Ordered boards 4/22/24 BMS/LoadtestV1.02R(b)  
R13 should be 1K or less for total 3 sense  
R4 should be 1K  
C17 should be at pin 10 MPU  
"loadtest" should be dropped

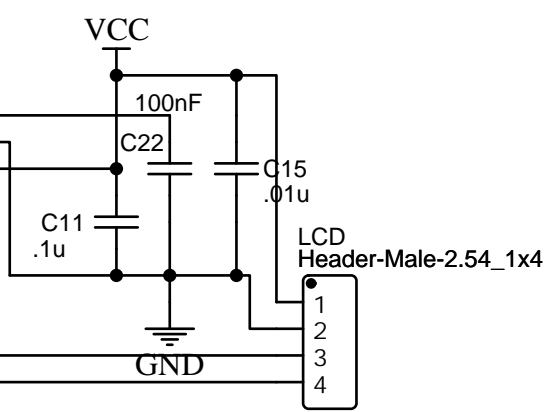
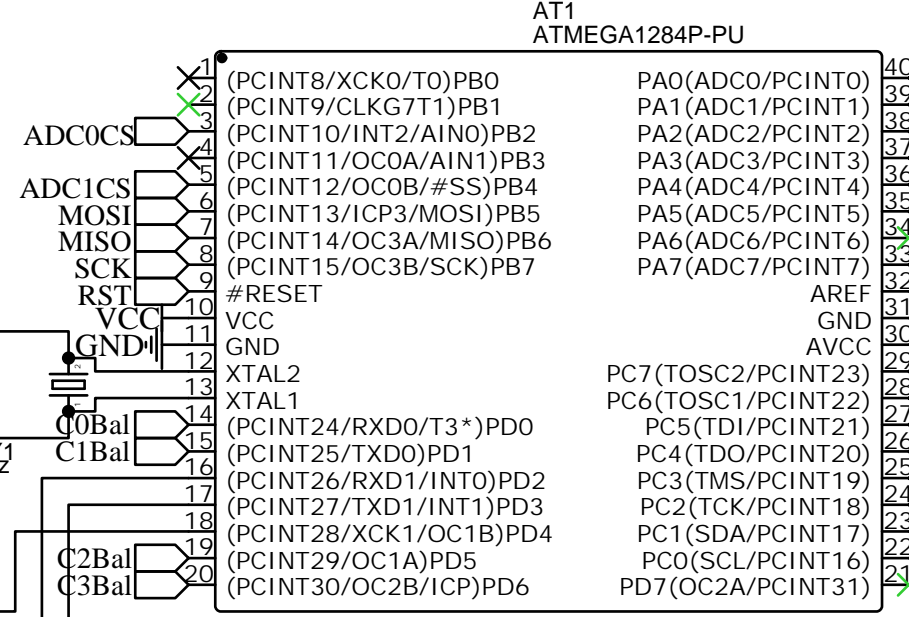
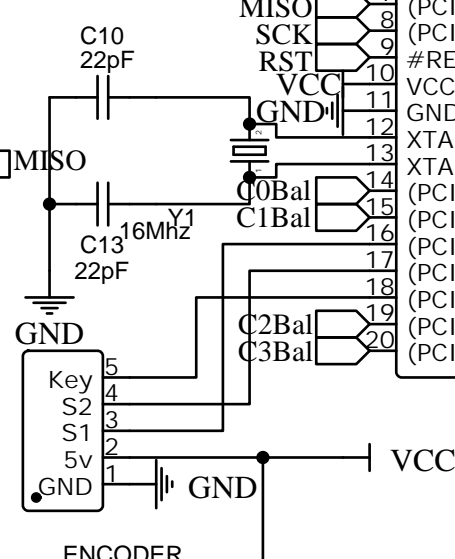
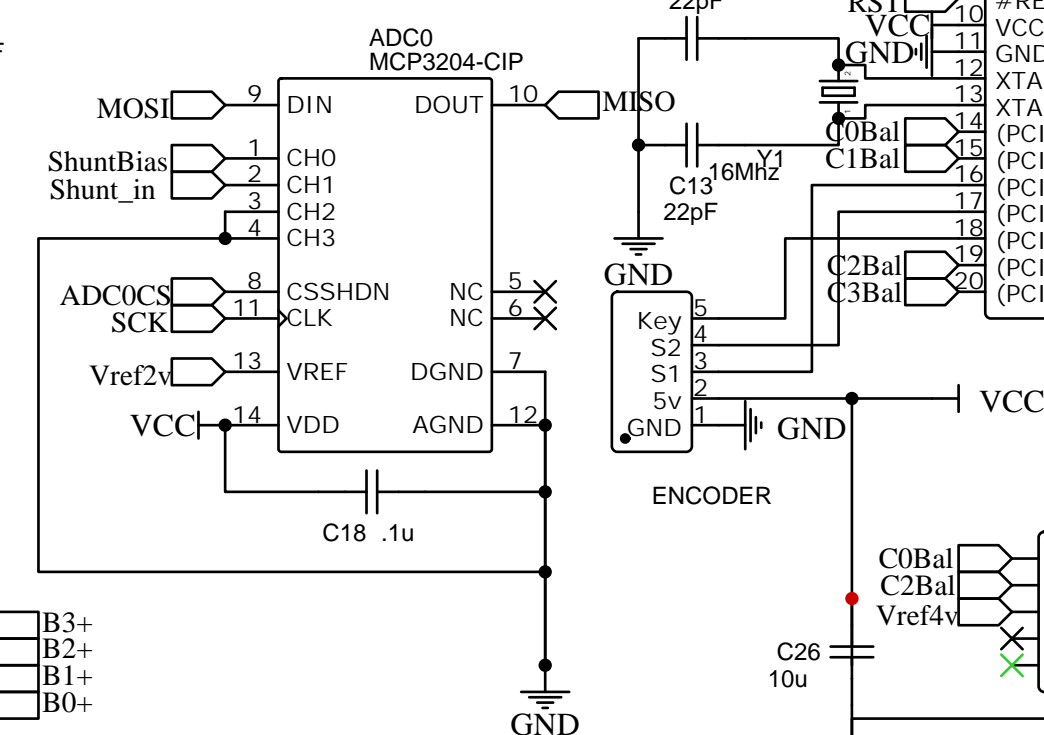
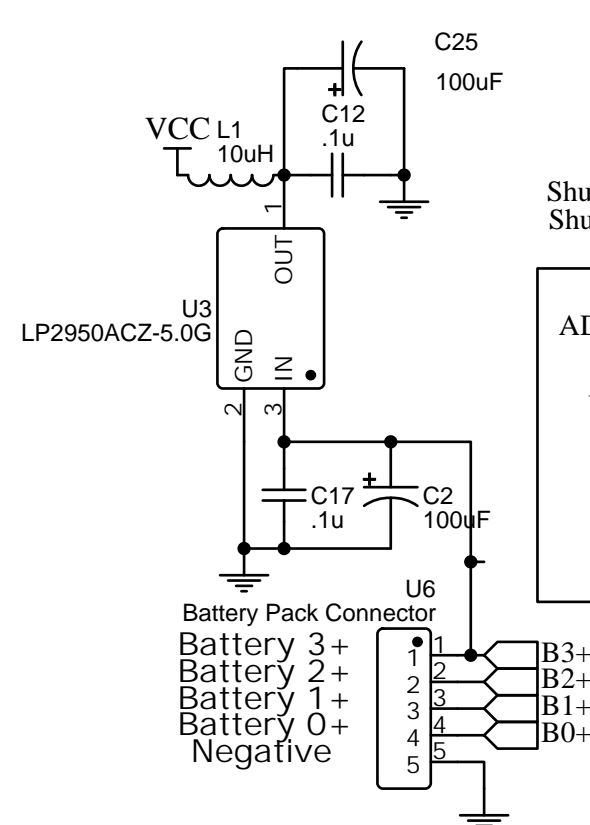
Notes printed on board are incorrect

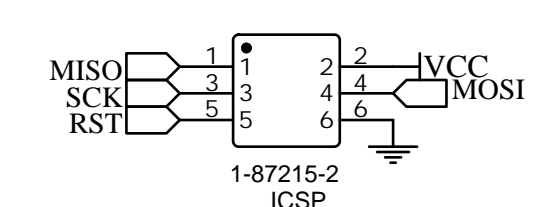
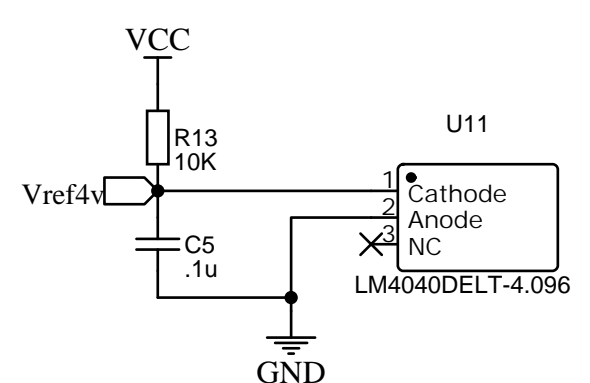
Need  
add presence for balance board  
C17 should be at CPU pin10  
bal cable reversed  
QD for temp sense  
fuses in bal board  
delete C1 on shunt board
